VE #201205 New Circle Road Rehabilitation and Reconstruction of KY4/US-60 Interchange Projects

Items #7-113.00 & #7-279.00
Fayette County, Kentucky

Value Engineering Study Report

Study Dates: December 10-14, 2012
Final Report Date: Pending

TITLE: Install a traffic signal on Versailles Road to eliminate Issue 4 - left turn lane conflicts

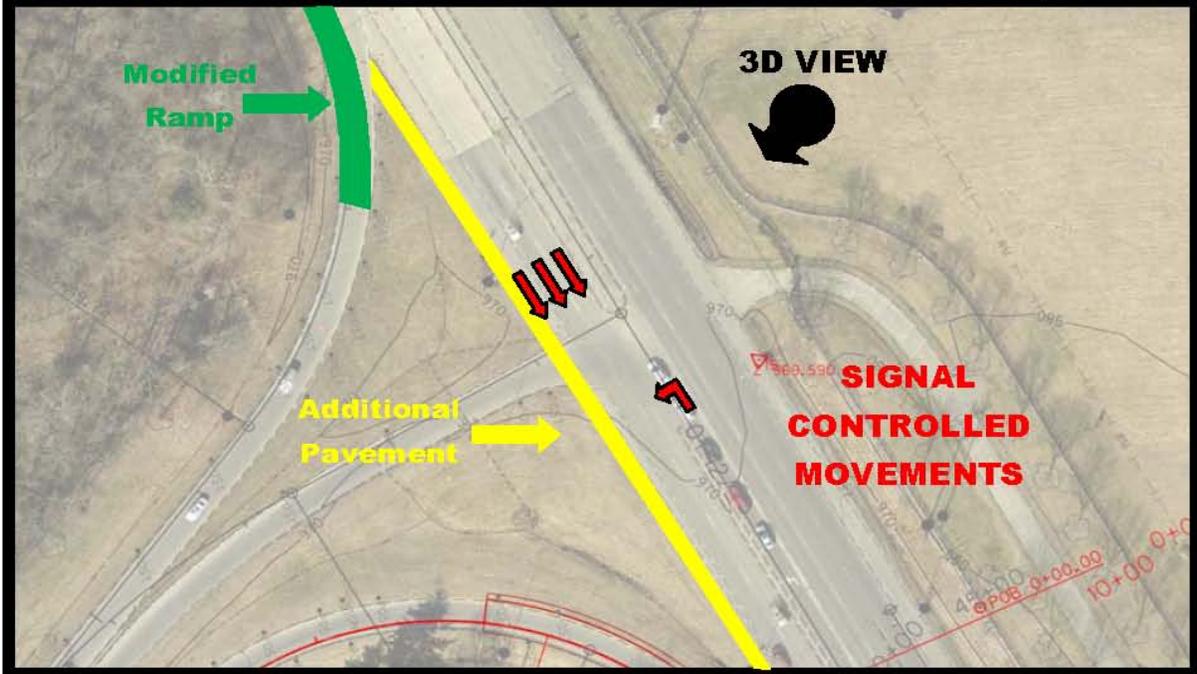
TITLE: Install a traffic signal on Versailles Road to eliminate Issue 4 - left turn lane conflicts				
FUNCTION: Improve Geometrics				
BASELINE ASSUMPTION:				
The left turn from westbound Versailles Road to southbound New Circle Road ramp is currently an uncontrolled movement. This left turn must yield to through traffic on eastbound Versailles Road. The remainder of the movements for this interchange are free-flowing.				
PROPOSED ALTERNATIVE:				
The proposed alternative would add a signal at this location to allow a protected movement from westbound Versailles Road left onto the southbound New Circle Road ramp. Traffic on westbound Versailles Road would remain free-flowing while traffic on eastbound Versailles Road would stop periodically while the left turn phase is green.				
BENEFITS		RISKS/CHALLENGES		
<ul style="list-style-type: none"> Left turns would be protected 		<ul style="list-style-type: none"> Rear-end accidents could increase along eastbound Versailles Road

The addition of a signal at this location would push the eastbound Versailles Road approach over a v/c ratio of one (1). A third eastbound lane would need to be extended through this intersection to keep v/c ratios for all signalized movements under one (1). To accommodate this third lane, a taper would need to be added to accommodate the eastbound Versailles Road to southbound New Circle Road ramp movement, which currently splits a lane off of westbound Versailles Road. This third lane would then continue through this signalized intersection and split off to the eastbound Versailles Road to northbound New Circle Road ramp. With this configuration the intersection would operate at a reasonable v/c ratio of 0.85-0.90 and the westbound left turn queue would fit in the storage provided.

TITLE: Build a westbound median ramp to the southbound outer loop

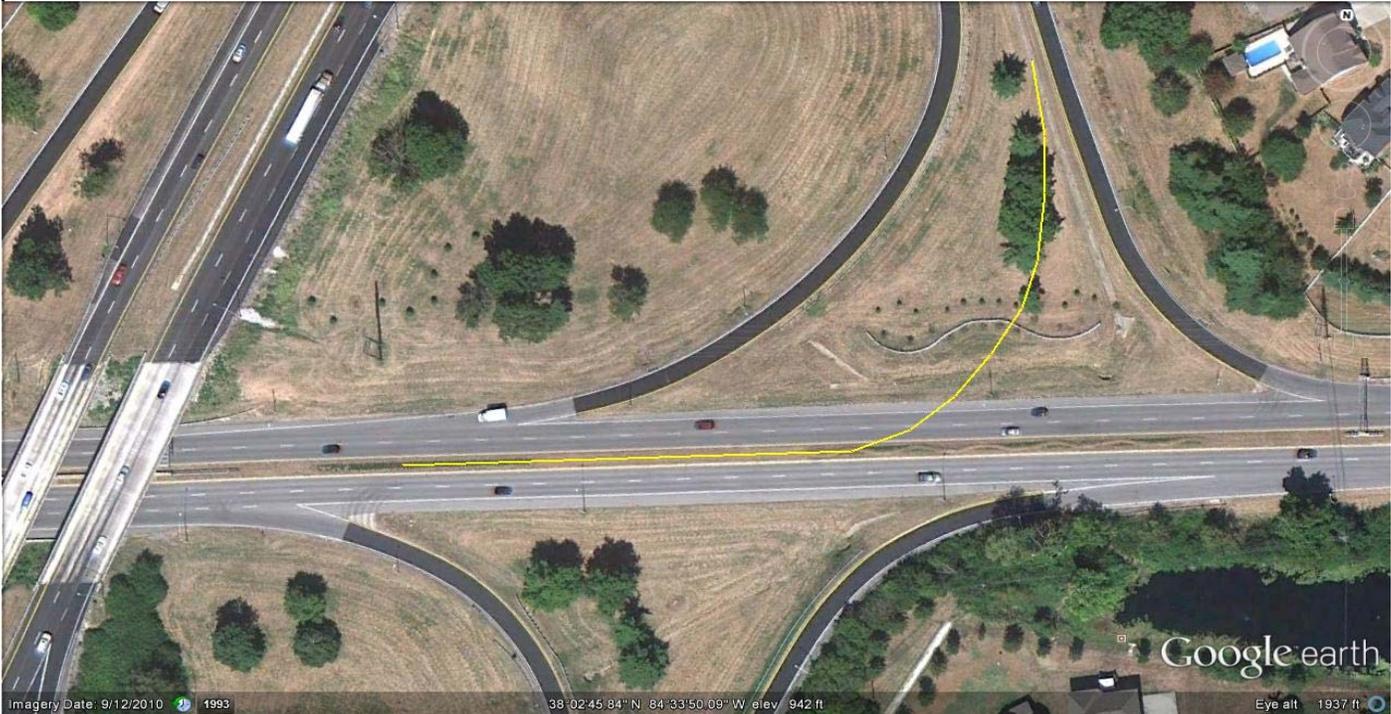
PROPOSED ALTERNATIVE:				
<p>Add a median ramp in US 60 with a flyover over US 60 westbound only. Ramp E remains as proposed in spill-thru so the eastbound through lanes can be shifted over 12 ft. under the bridge and the current inside through lane under the bridge will become the median ramp lane. Ramp D no longer needs to be realigned.</p>				
BENEFITS		RISKS/CHALLENGES		
<ul style="list-style-type: none"> Through lanes as well as Ramp E remains along a tangent parallel to the existing US 60 		<ul style="list-style-type: none"> Existing 16-ft median needs to widen from 19 ft. to 35 ft. to fit a 25 ft ramp with proper clearances 		
<ul style="list-style-type: none"> Reduces flyover bridge length 		<ul style="list-style-type: none"> Median ramp construction must be performed with traffic on both sides 		
<ul style="list-style-type: none"> Eliminates Ramp D modifications 		<ul style="list-style-type: none"> Crash cushion details will be needed to protect the innermost eastbound through lane from hitting the beginning of the ramp wall

This alternate reduces the length of the flyover bridge and eliminates the need to reconstruct and realign Ramp D to accommodate the merger with Ramp E since Ramp E no longer swings out wide into the area formerly occupied by loop Ramp G. This plan assumes a 25-ft. clear Ramp G flyover width (15 ft. lane, 4 ft. inside shoulder, and 6 ft. outside shoulder. This proposed new Ramp G is to be constructed using reinforced earth walls. New Jersey barrier with moment slab is mounted on the top of the wall and a New Jersey barrier shape is used along the base of the wall where parallel to through traffic each way. Allowing for 2 ft. clearance from barrier shape to driving lane plus 3 ft. for distance from inside the barrier face on the ramp to inside barrier face at the bottom of the wall, requires a total width of 35 ft. from edge of the driving lanes between eastbound and westbound traffic. Since the existing median is 16 ft., the median in the vicinity of the ramp will need to be widened a total of 19 ft. 12 ft. of this is acquired by using 12 ft. of the existing inner eastbound lane. The remaining 7 ft. is obtained by shifting the through lanes out 7 ft. or by reducing the shoulder width under the bridge from 12 ft. to 5 ft., or a combination of both. The bridge is a 200-ft., 2-span bridge using steel curved girders. This proposal uses a single column hammer head intermediate pier with the beams integral with the pier cap to minimize clearance issues and to allow the cap to cantilever over the driving lanes with the pier column placed just behind the New Jersey barrier. Using an 8% ramp and a 3.67% downgrade of US 60, 11.67 ft. of height can be achieved every 100 ft. For 16 ft. clearance and 7 ft. total bridge depth, 23 ft. can be achieved with a 200-ft. long ramp. The ramp length as depicted by the yellow line in the proposed alternative sketch is 380 ft. long. For this case, the ramp slope needs to be 2.4% to achieve the 23 ft. clearance.

TITLE: Widen both the bridges and roadway to one side in lieu of symmetric widening

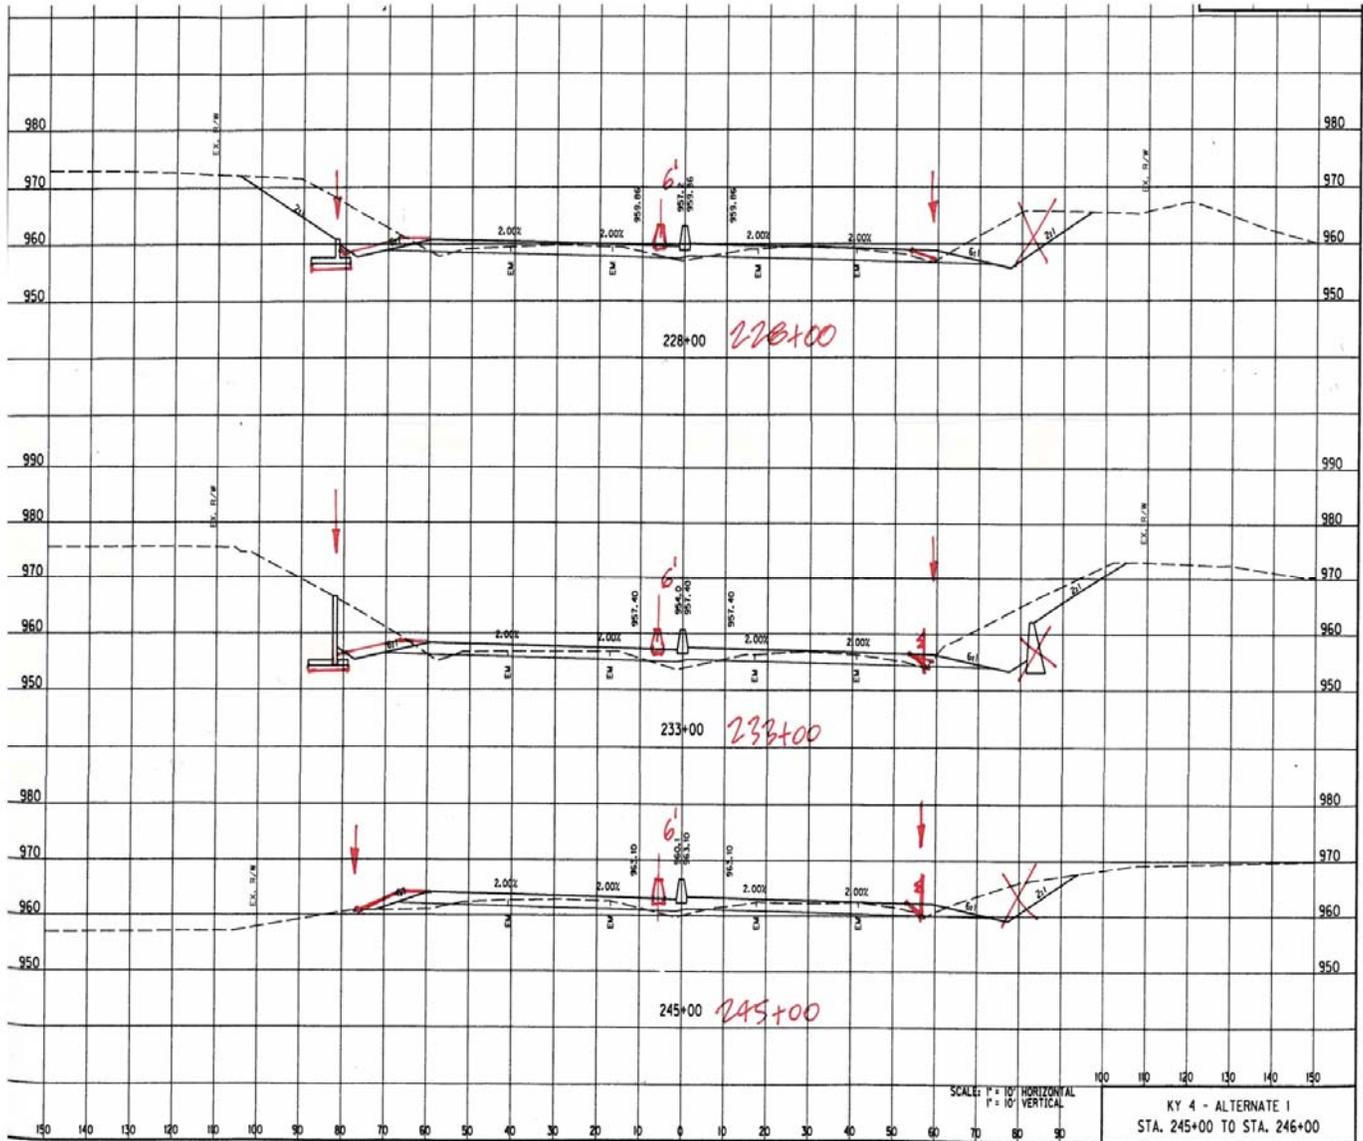
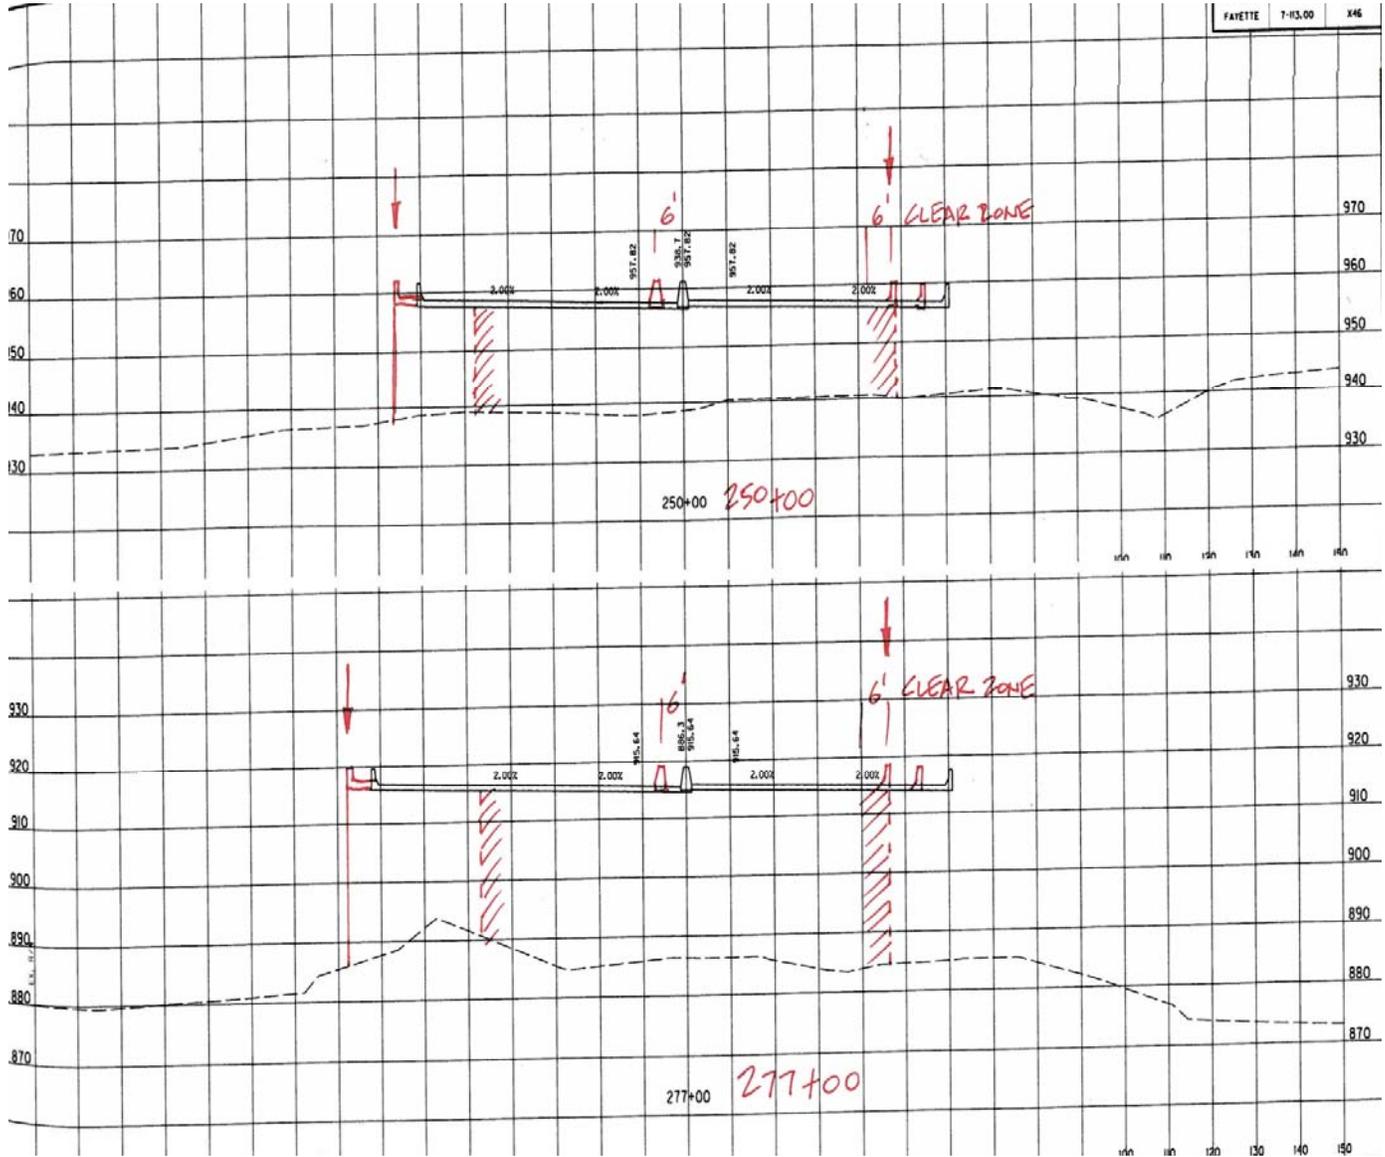
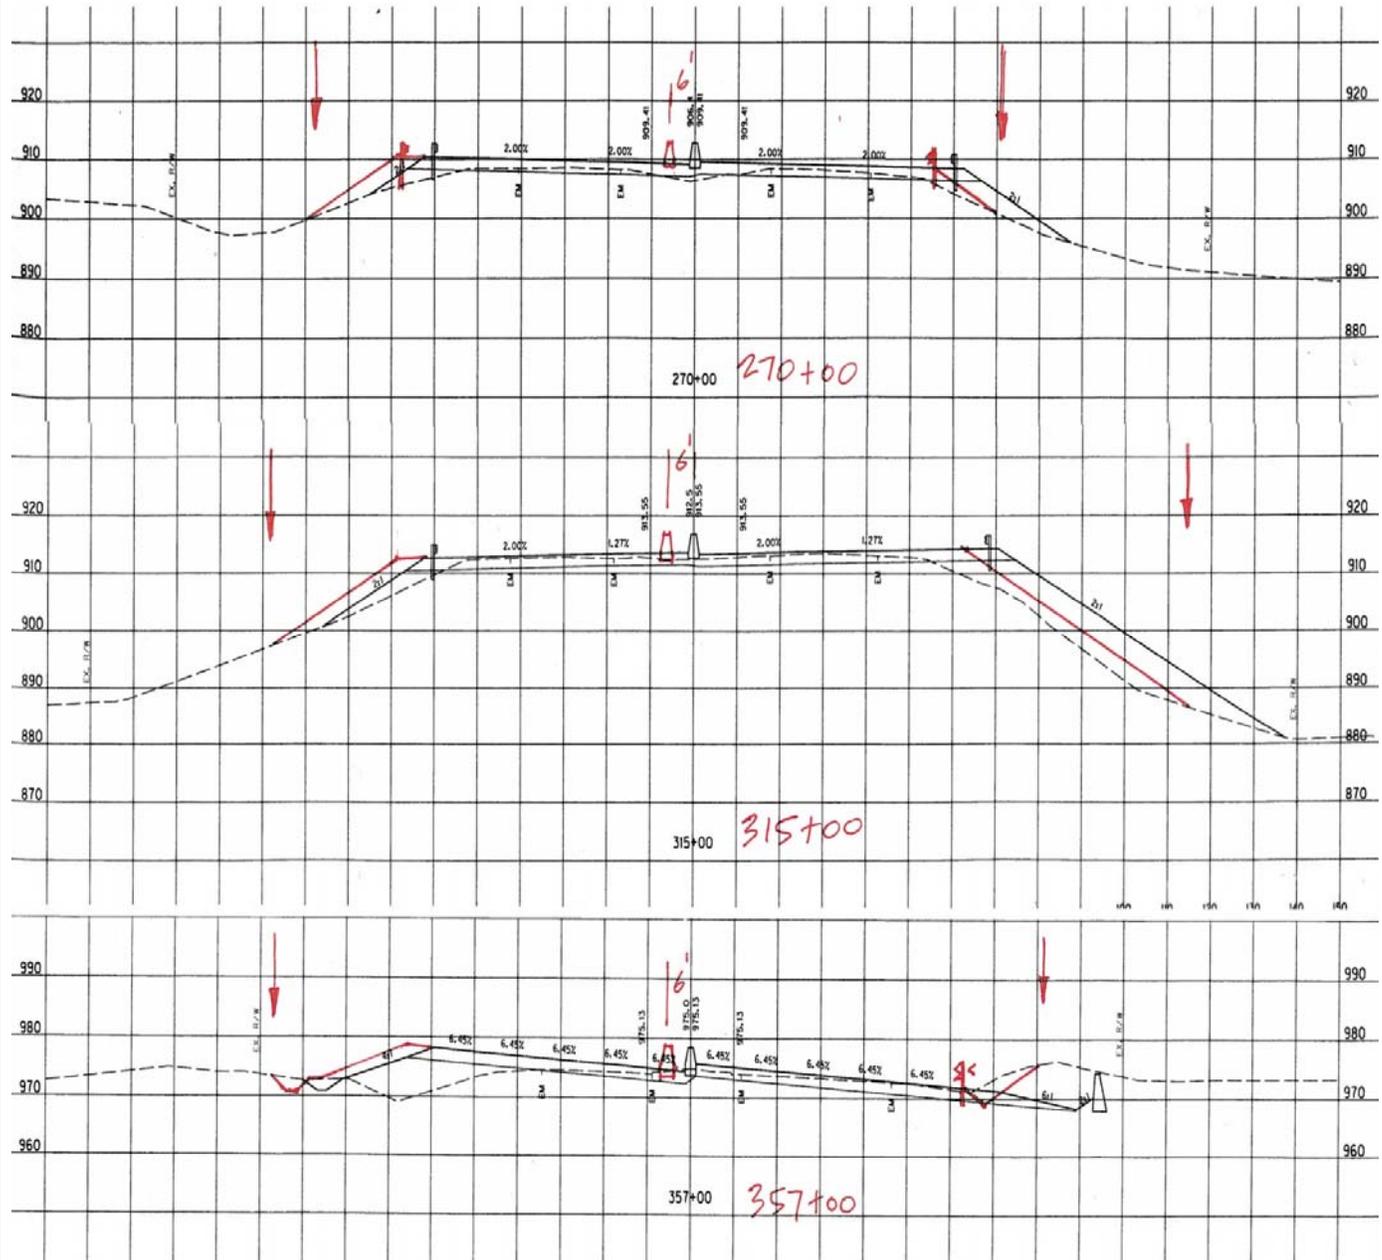
<ul style="list-style-type: none"> Reduces structure modification costs 		<ul style="list-style-type: none"> May still require a three phase traffic control maintenance of traffic sequence 	
<ul style="list-style-type: none"> Reduces roadway pavement costs 		<ul style="list-style-type: none"> Reduces clear zone from baseline in some areas 	
<ul style="list-style-type: none"> Can reduce noise by shifting to the north, noise source "NO CLOSER". Possibly reduce or delete noise walls 		<ul style="list-style-type: none"> 	
<ul style="list-style-type: none"> Takes advantage of existing right-of-way 		<ul style="list-style-type: none"> 	
<ul style="list-style-type: none"> Will make it easier to achieve maximum overlay by matching grade 		<ul style="list-style-type: none"> 	
<ul style="list-style-type: none"> Will provide increased improvements if the lane widths or shoulders are reduced 		<ul style="list-style-type: none">

TYPICAL SECTIONS
IT-01

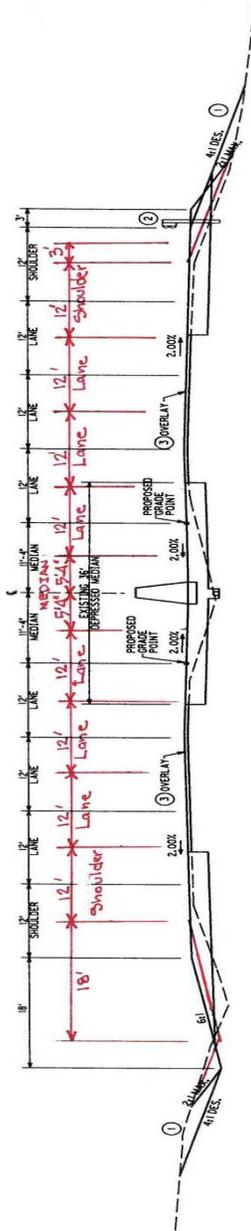
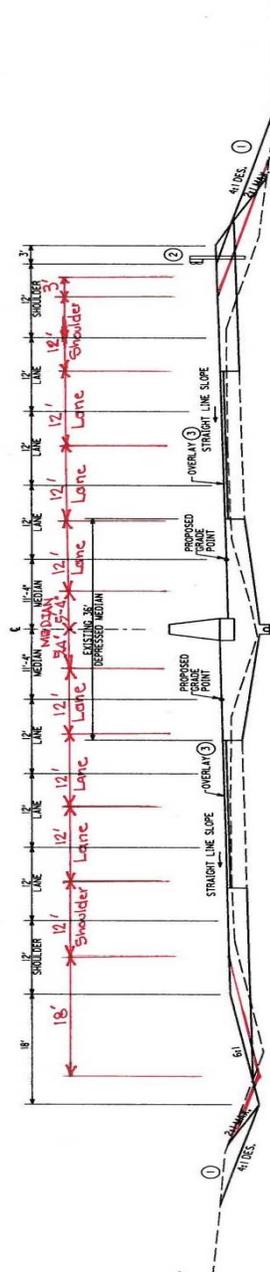
A narrower inside shoulder width would necessitate a new look at the Temporary Traffic Control Plan. Preliminary evaluation by the VE team determined that maintaining 2 lanes in each direction is feasible. A design exception would be required.

Add Variable Message Signs (VMS) on the mainline and the associated roads crossing New Circle Road, to aid in congestion control

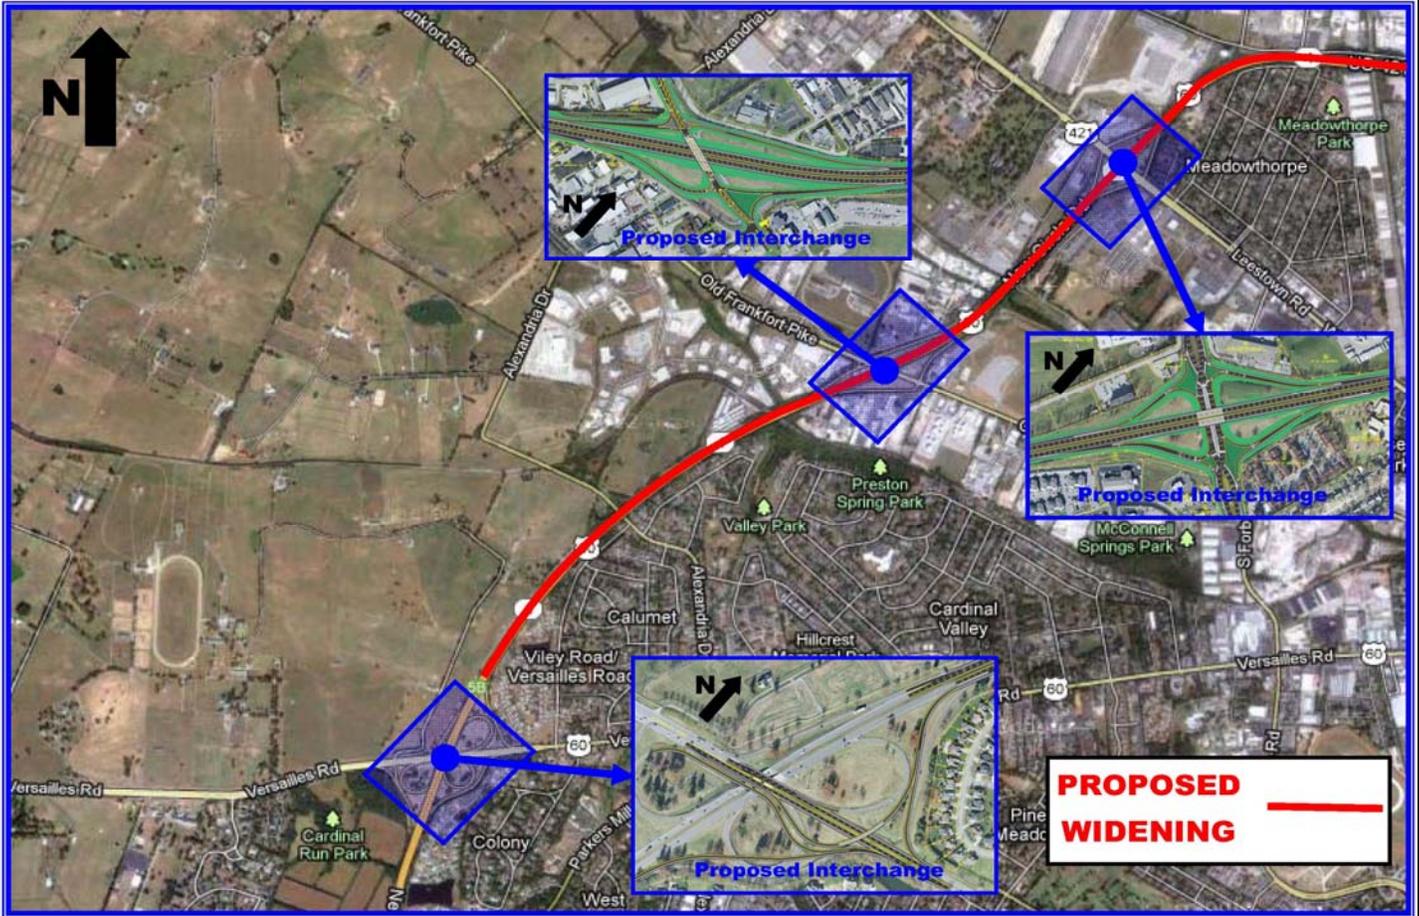
Variable Message Signs can be installed in a number of ways; on structures spanning the roadway using a truss system, pole mounted, or fixed to an existing structure such as a bridge. For a message sign spanning New Circle Road, a truss mounted overhead sign would be the best option. Pole mounted signs would provide information to eastbound motorists on Versailles Road and Leestown Road as they approach New Circle Road.

The operation and maintenance of the proposed variable message signs would be best served by the City of Lexington. Lexington's Traffic Management Center monitors traffic conditions throughout the city, giving them the information they would need to update messages as needed.
